Notice of Appeal

We are appealing the Occupancy Permit issued for Civic # 11-13 Essex Crescent under City of Charlottetown File No. 1127984. The permit was issued January 7, 2022 for " Occupancy Permit: New Semi-detached dwelling"

RE: PROJECT 21185 | 118 Royalty Road | Surface Water Drainage

Figure 1 – Plan 41983. LRO, Windsor Park Subdivision Phase 3 dated October 9, 2019

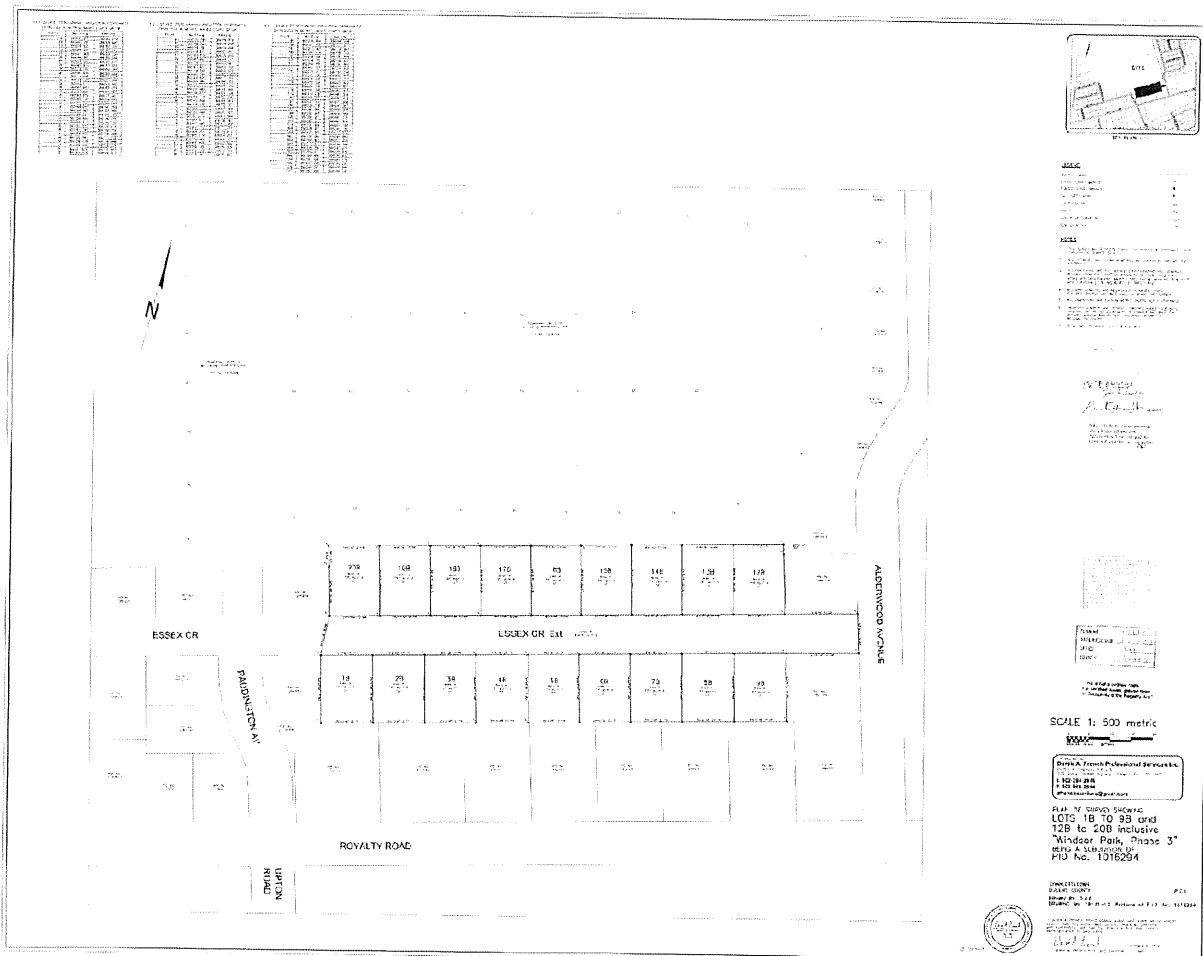
1. Schedule "A" the Master Plan, being the Plan of Subdivision approved by the City of Charlottetown, June 2, 2020 and filed in the LRO as Number 41983 depicts no drainage easements. Under the SRSA s.7c, the developer is required to submit drainage easements where

required. It would appear the developer did not foresee a need for any drainage easements along the southern boundary of the lots fronting on Essex Crescent.

2. Under the SRSA s. 10 b. appropriate siltation/ mulching measures are to be in place to avoid excess surface water run-off during this period". No erosion control measurements were found in place on the rear boundary of the lots fronting of Royalty Road. The plan set making up Schedule C" of the SRSA does not depict an Erosion and Sediment Control Plan, or a Storm Water Management Plan.

Figure 3 As-found elevation plan with contours and drainage patterns

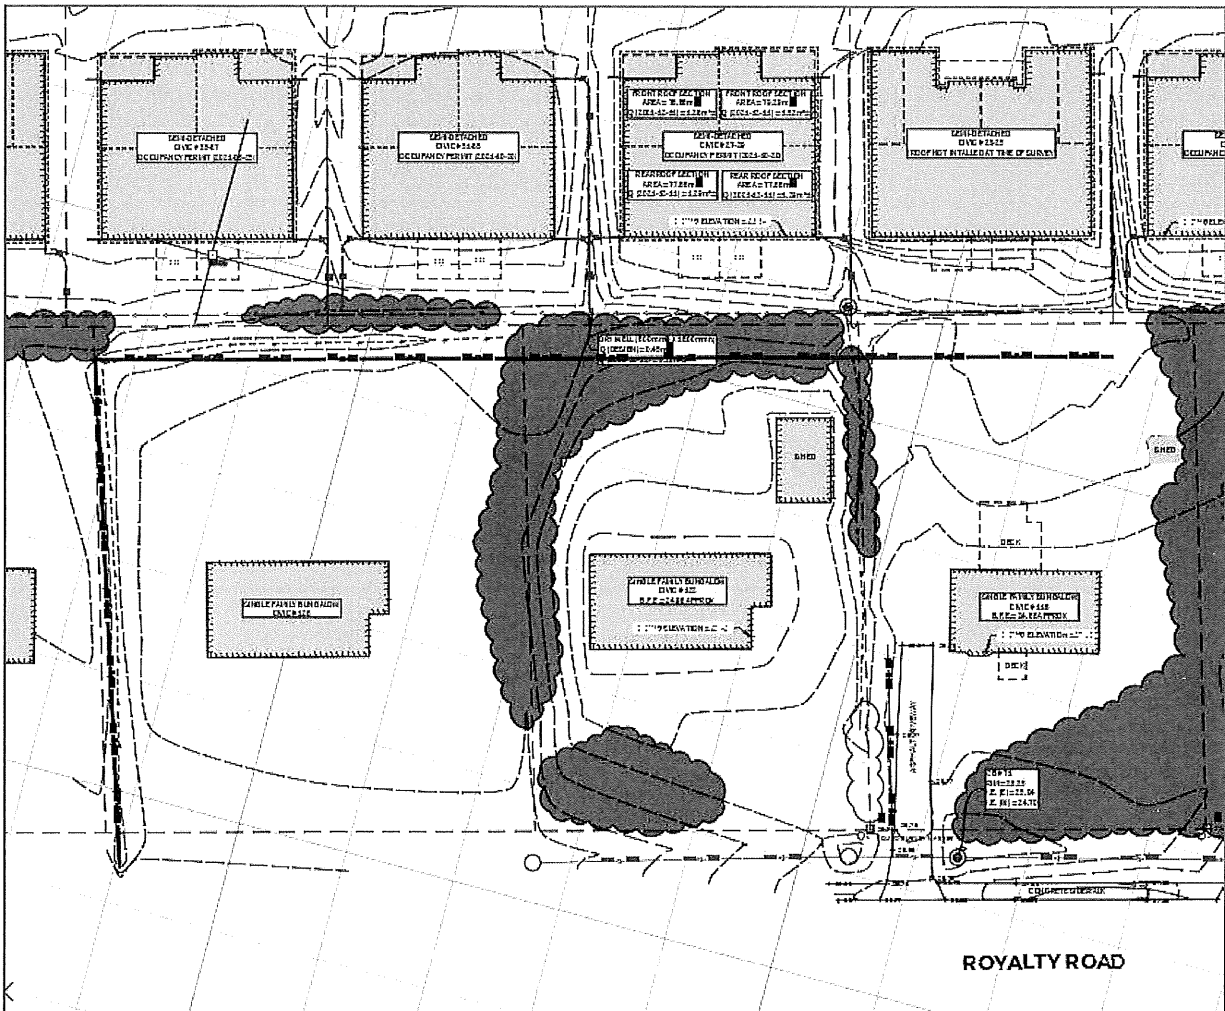
In the initial design and review process for the subdivision, it should have been observed that the rear of the properties being approved had an elevation below the final design of the road. The road and existing development created a barrier from which water could be free to flow ultimately to the creek at the bottom of the hill. No path was provided in the design to allow for the dispersal of surface waters during high storm events.

During the approval of the individual lot grading plans, the viability of dry wells should have been questioned. Best Management Practices, suggest creating dry wells, that can handle the largest of storms and that can disperse of the water collected, in no less than 72 hours. This requires proper analysis of soil for hydraulic capacity. Best Management Practices, also suggest providing g routes for the surcharge from the drywell to get to a storm system downhill. The individual plans provide no such mechanism.
